Backfeed voltage during 2, 3 and 4 pair operating modes

May 2018
Yair Darshan
Rev007

Objectives

- To investigate the effect of excluding backfeed requirements for 3-pair mode.
- To check if and in which parts, the IEEE802.3bt D3.4 need to be updated as a result.

Problem #1 with the existing text vs. existing legacy and pre 802.3bt standard PDs implementations

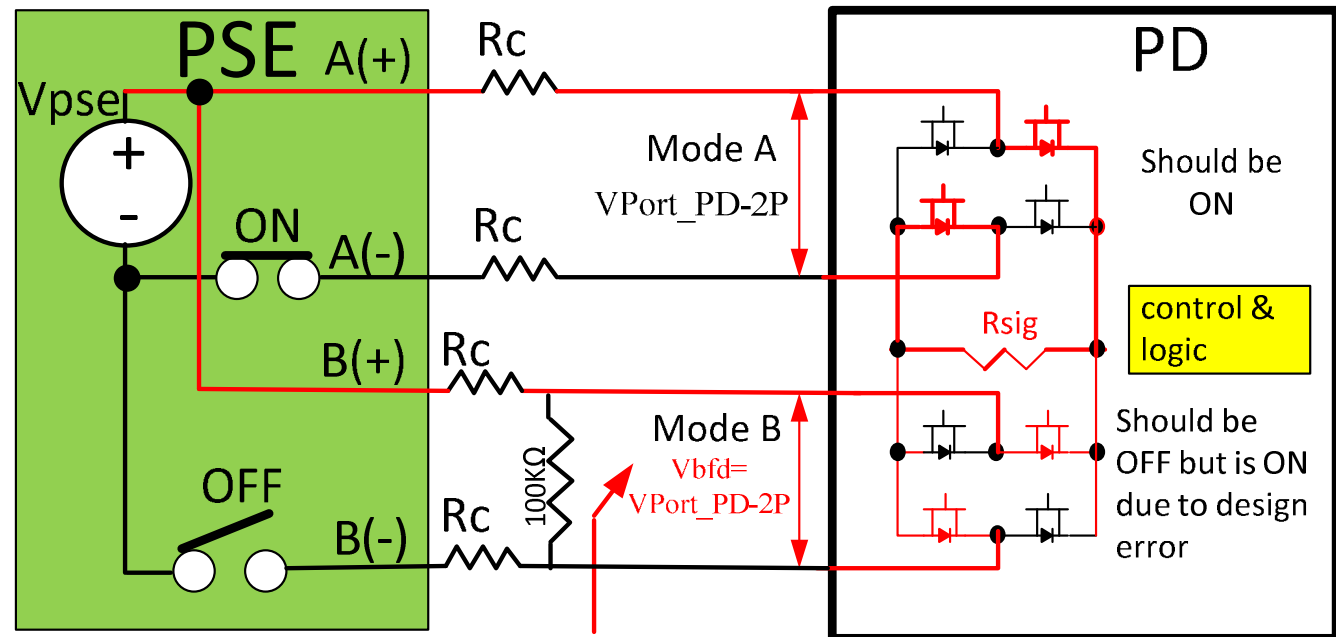
- Some **Ideal diode bridges** in the market used with Type 1 and 2 PDs and pre-802.3bt SSPDs will fail to meet the backfeed requirement when operated in 3-pair mode¹.
- in most 4-pair PSE implementations, all positive leads are tied together and only the negative leads are switched. This results in 3-pair mode when a 4-pair PSE is powering over 2-pair

Note 1: Found during the last Plug Fest when pre-standard 802.3bt PDs where connected to pre-standard 802.3bt PSEs. Designers didn't verify that these specific implementations doesn't 100% match diode bridge behavior (which doesn't have the backfeed issue in 3-pair).

Should we include (limit to 2.8V/28uA) or exclude (allow up to 57V with ILIM-2P) V_{bfd} requirements for 3-pair mode?

New issues – Detection pollution

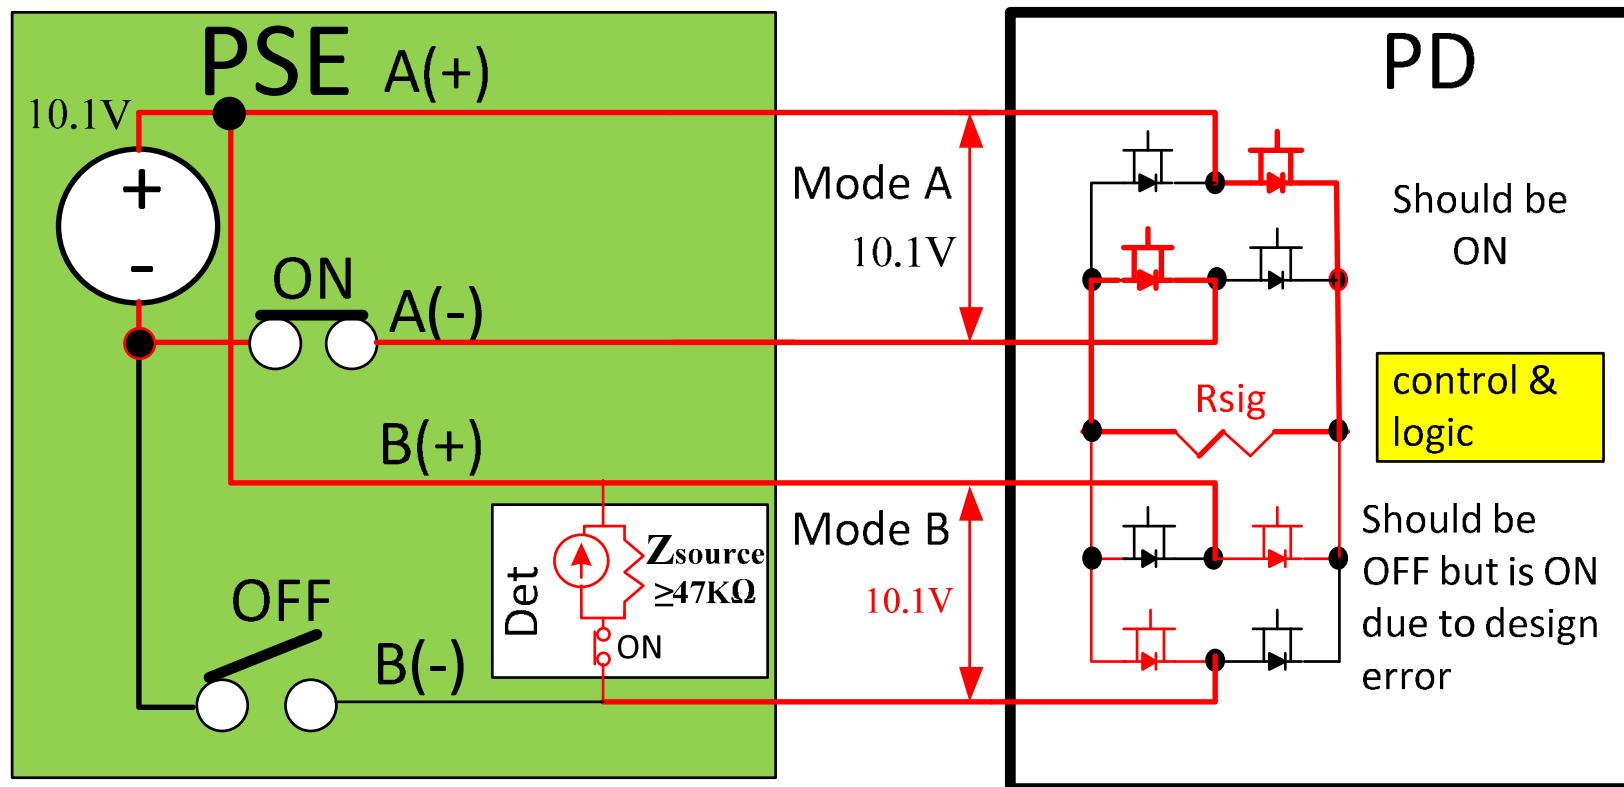
Why to include backfeed in 3-pair for up to 10.1V?

- Detection will be polluted if we allow ideal diode bridge to be ON in SSPDs during detection by the other alternative Zsource (Figure 145-19) in the detection circuitry.
- Zsource will be in parallel to Rsig $\rightarrow 45K \parallel (25K \cdot 0.95) = 15.35K < 19K \rightarrow$ Fail.
- Solution: To require meeting backfeed for at least 10.1V OR meeting valid or invalid detection signature with the presence of Zsource hence PD will know what to do e.g. meeting old backfeed requirement in this region without forcing implementation.

New issues – Classification pollution

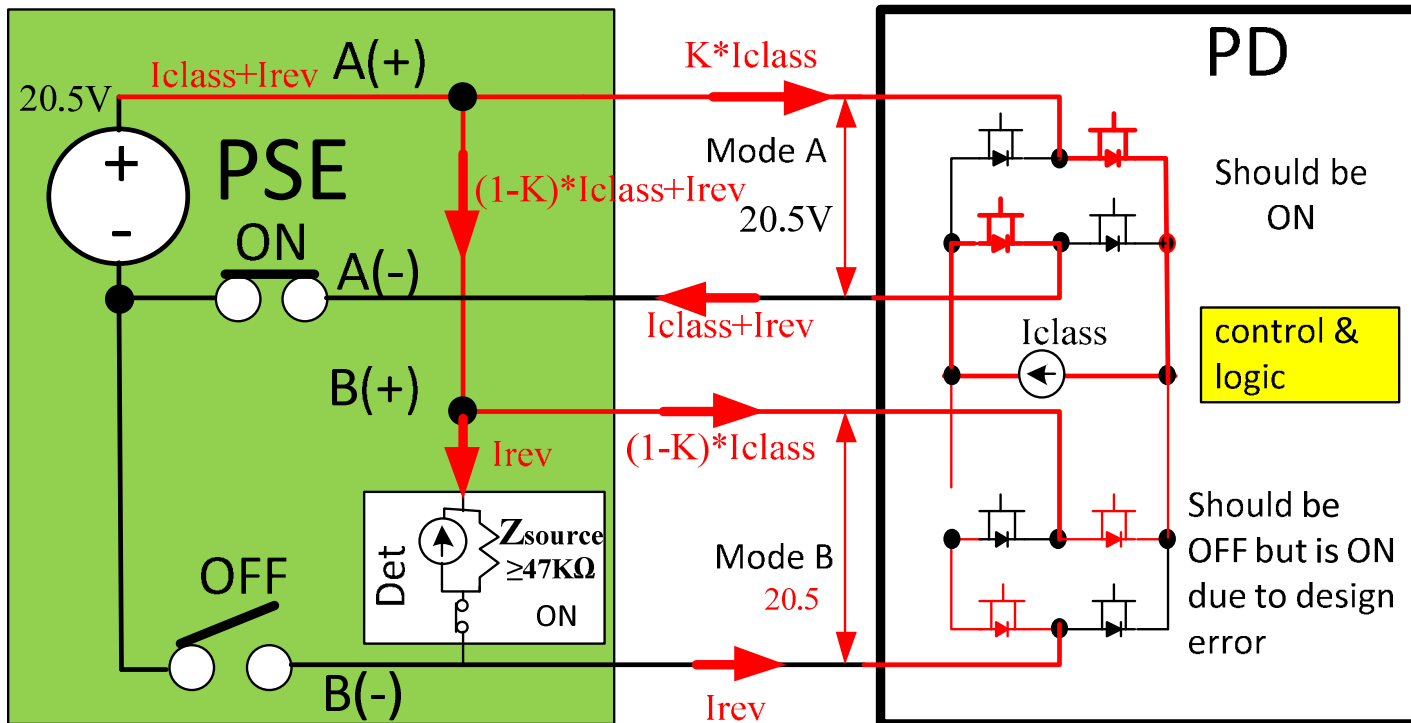
Why to include backfeed in 3-pair for up to (20.5V+margin?)

- In SSPDs we have single classification signature
 - Classification current may be changed by $20.5V/R_{source_min}=0.436mA$ (or I_{rev}) which will require tighter accuracy measurement
 - e.g. instead of 3mA margin between class 0 to class 1 and class 1 to class 2 we will have to meet $(3mA-0.436mA)$ margin (and it is worse since $I_{rev}=1.3mA$ max)
- If the legacy ideal diode bridges ALSO violates backfeed during the 30V range then it is a major design mistake and we should not allow it!

- To require meeting backfeed in 3-pair for at least 20.5V+margin **OR**
- Limit I_{rev} to 0.5mA at the range of 10.1V to 21V.

Source current vs.. Sink/draw current

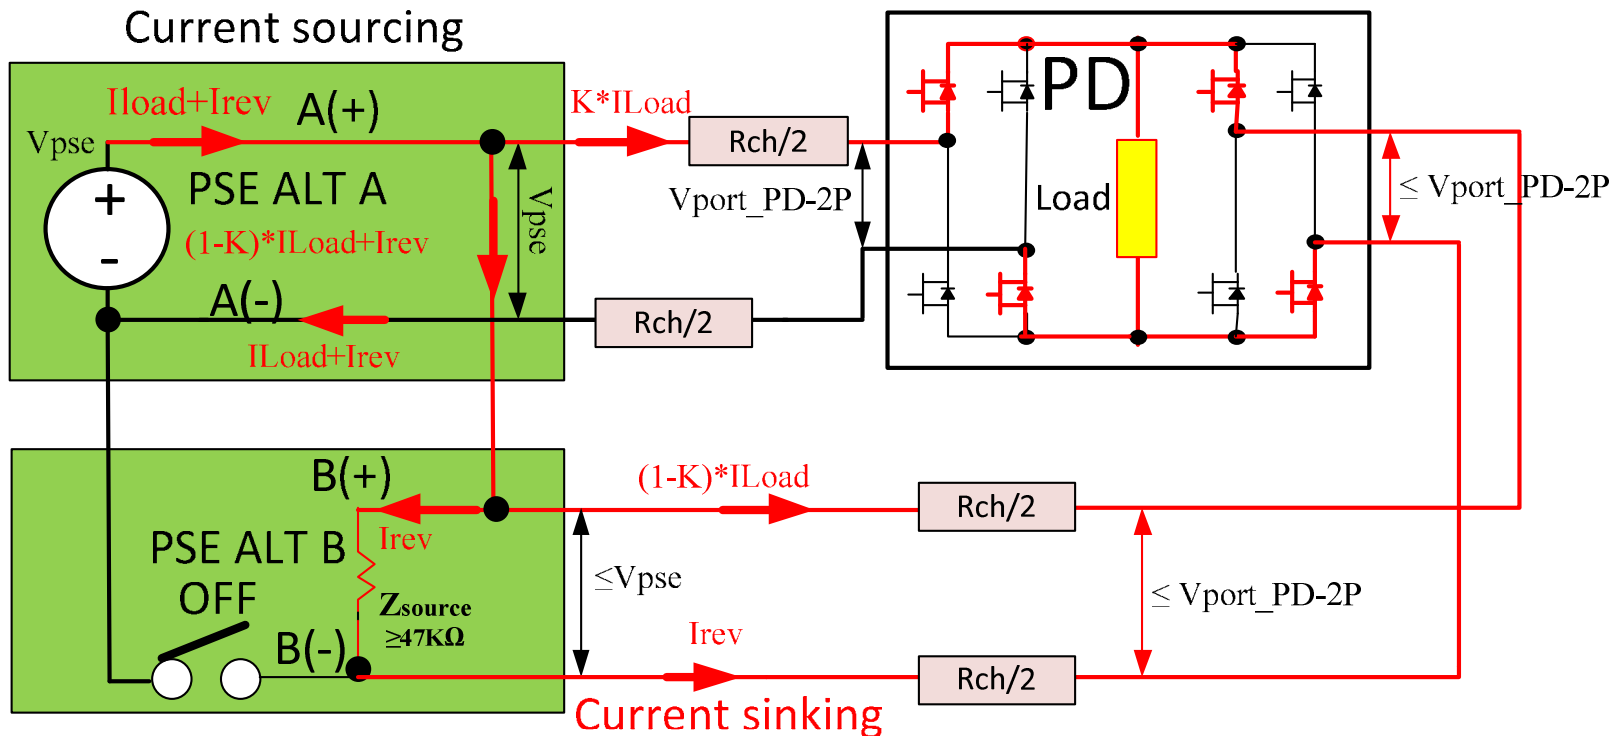
- When ideal diode bridge is not meeting backfeed under 3-pair condition it will cause the PSE Alternative that is OFF or detecting to **consume** up to $57V/45K=1.3mA$ or $\sim 0.5mA$ during classification operating voltage range.
- A device when it is OFF, can't source current. It can only be additional load to other active load.
- Alternative A PSE is powered, delivering power to the PD and the PD backfeed voltage to ALT B PSE that is OFF and cause Z_{source} to dissipate power.
- Therefore, PSE ALT B negative pair is drawing current.

When a 4-pair capable PSE provides power in 2-pair mode, whereby two pairs are connected to the positive VPSE, and one pair is connected to the negative VPSE, a single-signature PD may reflect a voltage of up to VPSE back onto the unpowered pairset. See 145.3.8.8. This can cause a reverse current to flow, named I_{rev} , defined in Table 145–16. Reverse current is current flowing out of the PSE on a negative pair.

The PSE shall not **source** cause a current higher than I_{rev} , as defined in Table 145–16, **to flow on the negative pair**. This requirement holds only when no power is being sourced into the PSE.

Annex D: List of issues to resolve/investigate

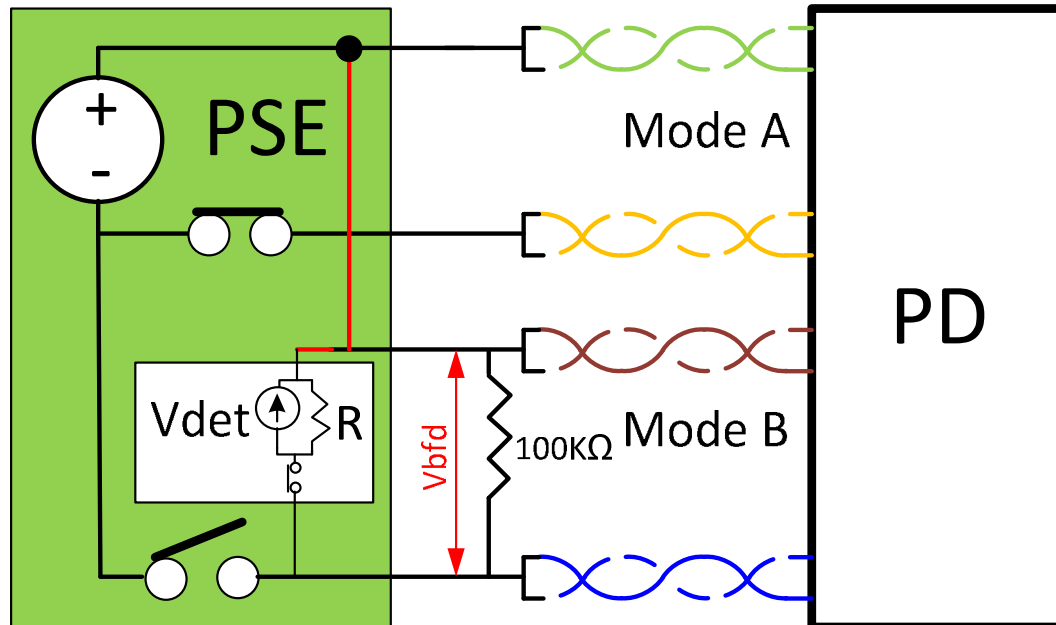
- Test conditions: Applying high backfeed voltage (VPort_PD-2P) to the unpowered pair of a 4-pair PSE when connected **to an ideal diode bridge from a schematic that was supplied to me¹**, in the following cases and checking for:
 - damage to existing 4-pair PSE detection circuitry that was used to see up to 30V during detection and backfeed voltage up to 2.8V and now may see backfeed voltages up to 57V.
 - PDs using wall adapters. If excluding 3-pair, PSE or PD or bot will be damaged since maximum voltage and current are not specified.
 - Damage or interoperability issues in a typical Endspan/Midspan configuration
 - When a PSE is connected to a SSPD through crossed cable: Damage to the detection diode across the PI due to reverse polarity¹?

When a PSE is connected to SSPD through crossed cable: safety (>60V) between the two modes¹?

- increasing PSE susceptibility to cross leakage current issues that will prevent successful detection on adjacent pairs/ports (now leakage may be higher by $57V/2.8V \approx 20$)
- Effects of backfeed violation on detection and classification
- **Other? Group/system vendors need to check for other use cases to ensure we are not creating problems in such late stages of the standard.**

Annex F: Endspan/Midspan configuration

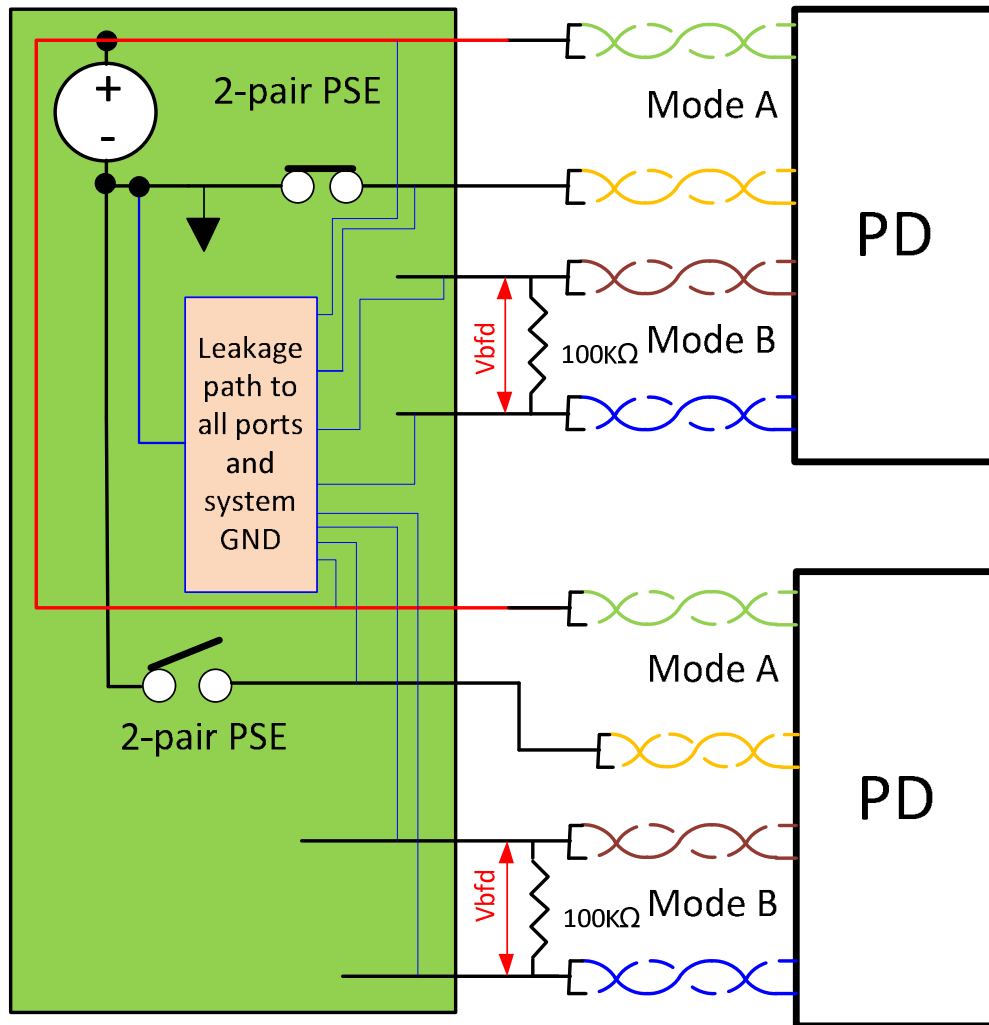
- Since a Midspan, when connected to Endspan, breaks the DC continuity over at least one positive pair, ***the 3-pair mode is avoided*** which results in true 2-pair mode operation, which meets the backfeed requirement.
- **Conclusions: No issues with Endspan/Midspan configurations if we exclude backfeed requirements in 3-pair mode.**

Annex H3: increasing PSE susceptibility to cross leakage current issues between pairs/ports in a multiport systems.

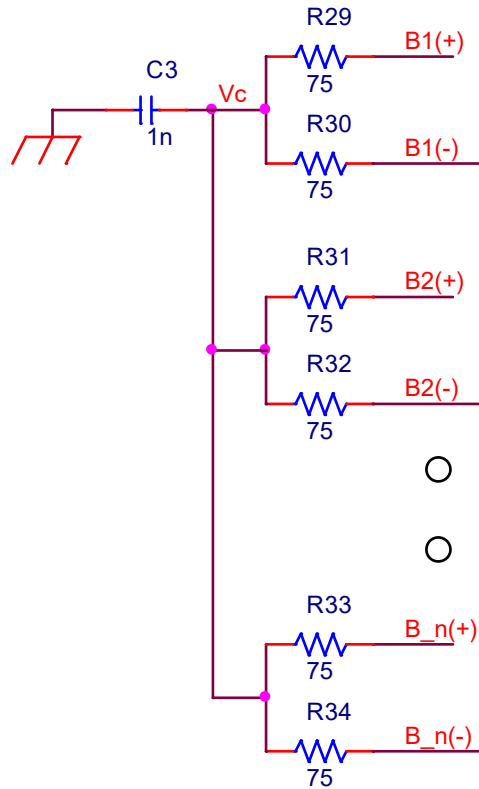
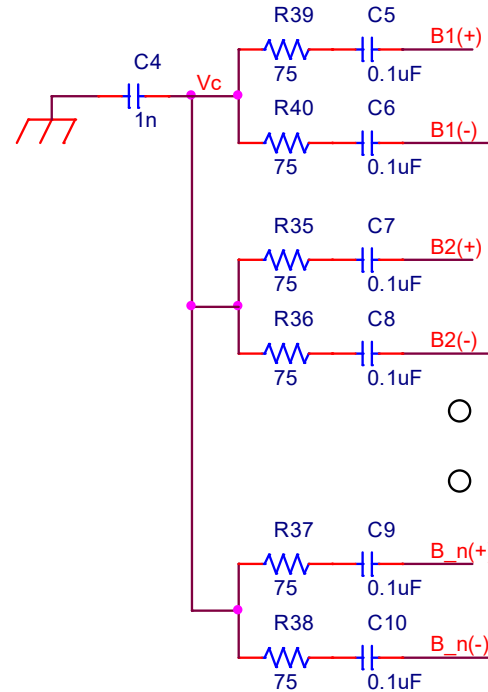
| # | PSE Config | Termination Config. (See Annex H2) | Results |
|---|---|------------------------------------|--|
| 2 | 3-Pair Type 3/4 PSE operating over 2-pair (3-pair mode) | B | <p>Conditions: -Alt A on 1st port is ON. -Alt B on 1st port ideal diode bridge in ON ($V_{bfd} \gg 2.8V$, $I_{bfd} \gg 28\mu A$)</p> <p>Results: $V_c = 42.9V$, $V_{sig} = 1.081V < 2.8V$ when only one port is ON. $V_c = 31.296V$, $V_{sig} = 1.1347V < 2.8V$ when 3 ports are ON and one is OFF. Each port that is ON increase V_{sig} by 17.66mV with cap leakage resistance=10MEG. -will pass detection until the 97 port is ON.</p> <p>Conclusion: -we can exclude backfeed in 3-pair as long as Termination config B is carefully used and MOSFET $R_{off} \gg R_{sig}$.</p> |

Annex J: Addressing dual-signature PDs

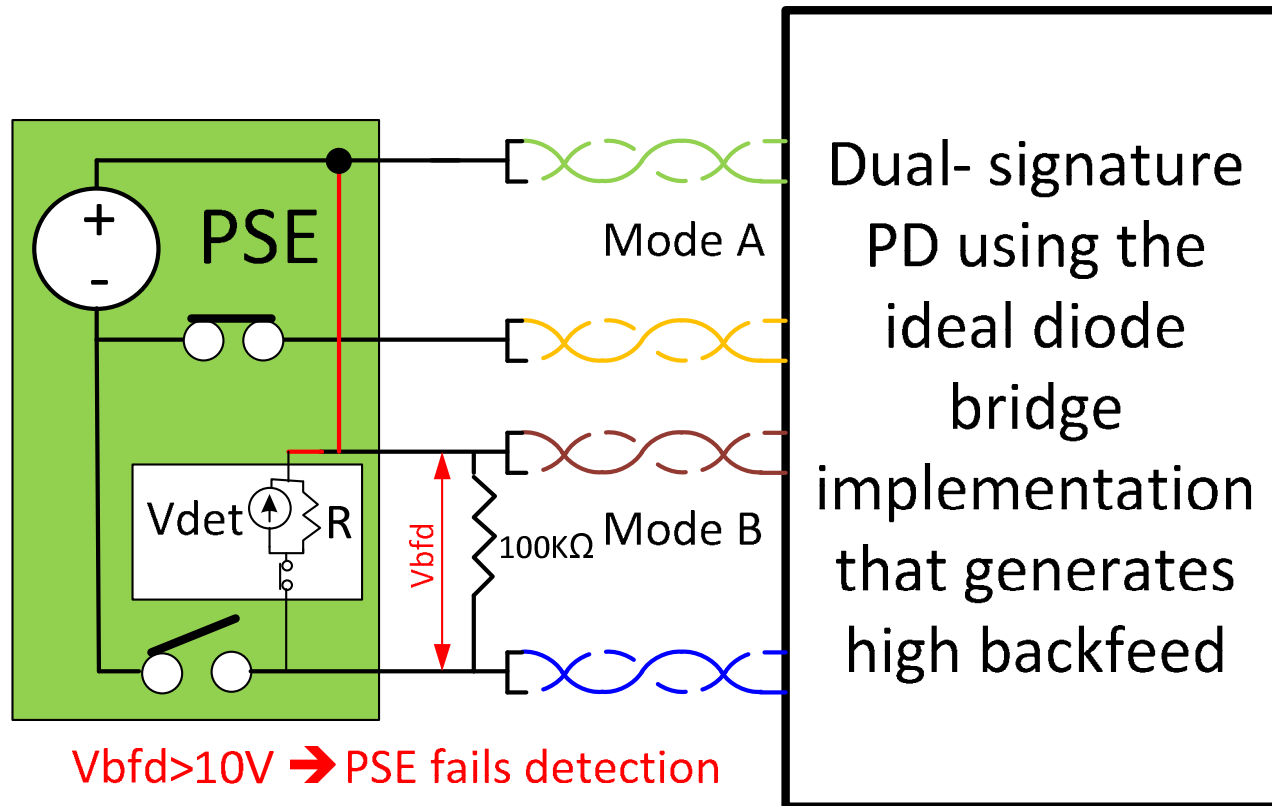
- The current text looks like it covers both single-signature and dual-signature PD, however dual-signature PDs must meet backfeed for any valid configuration in Table 145-20 (2-pair, 3-pair and 4-pair) and we need to ensure this in the final text of backfeed, if it is going to be changed.

If excluding backfeed from 3-pair, to do it only for SSPD and add new text to include backfeed requirements for dual-signature PDs in 2-pair, 3-pair and 4-pair modes.

Annex K1: PDs with wall adaptor

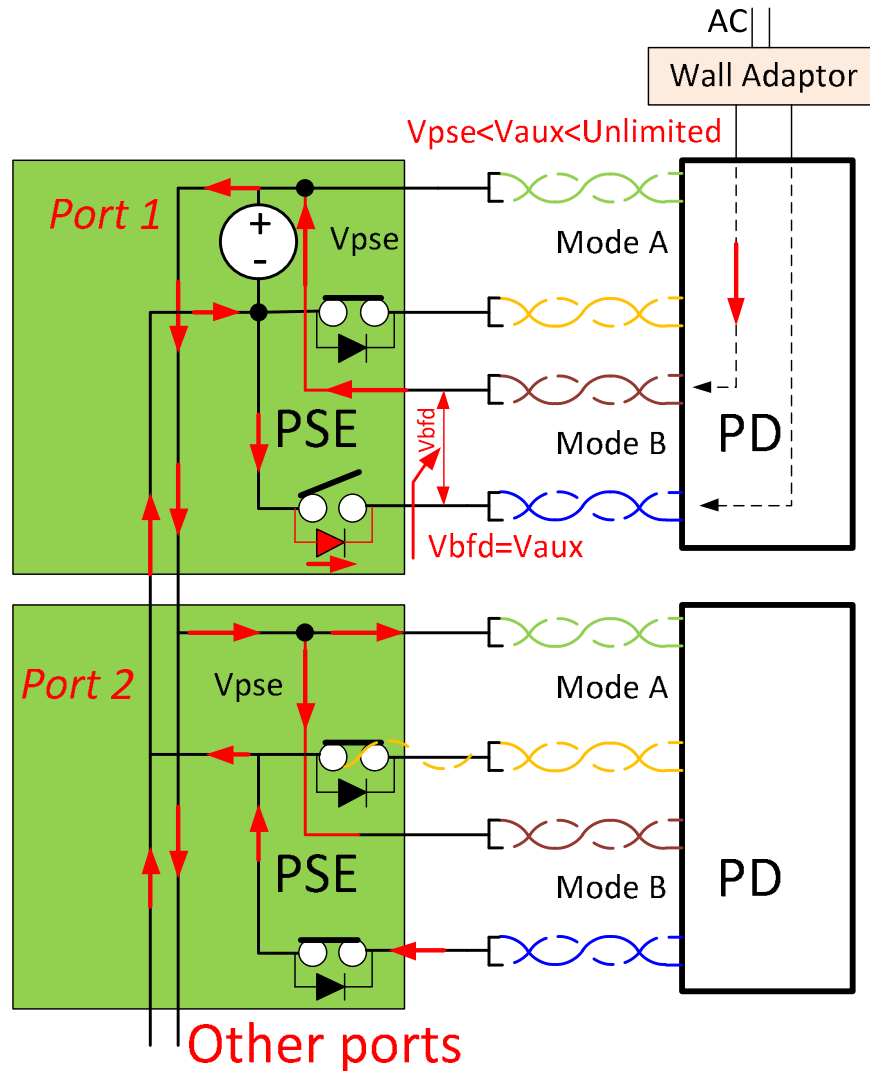
- The concern is that violation of PD back feeding has the same results as if PD is sourcing power which is ***not acceptable!***
 - PDs with aux power supply are allowed by the standard
 - Their maximum voltage and current limits are not specified
 - ***The concerns are:***
 - Voltage > V_{pse_min} . PD aux power supply will replace PSE PS and power all the ports and will damage the PD aux power supply
 - Voltage > 57.
 - It will damage PSE
 - Violate the safety spec (SELV).
 - PD aux power supply will replace PSE PS and power all the ports and will damage the PD aux power supply.
 - See problem and solution next slide

- Risk of damaging:
 - PSE (If $V_{aux} > 57V$)
 - PSE MOSFET body diode of port #1 ALT B
 - PD (Aux supplies all the power to the 1KW PSE load....)
 - Other PSE connected instead of Aux

Need to keep the requirement that PD shall not source power and clarify in additional text that backfeed is not sourcing power.
